SUBJECT: Chassell Township Wastewater Treatment Plant and Septage Waste Receiving Facility

Operating Plan Approval

CHASSELL TOWNSHIP SEPTAGE RECEIVING FACILITY OPERATING PLAN

Septage Waste Receving Facility Checklist

Chassell Township Septage Waste Receiving Facility Location

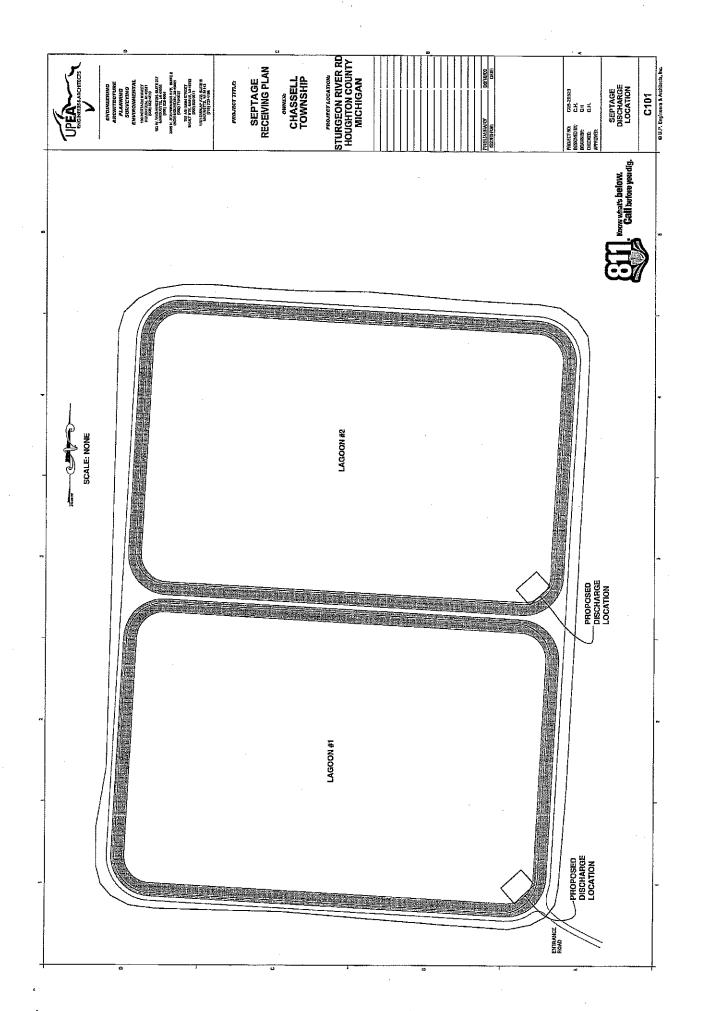
| Requirement | Yes | <u>No</u> | Comments Plat map provided showing the |
|--|-----|-----------|---|
| Location of septage RF. | X | | location. DNRE provided aerial photo of the facility. |
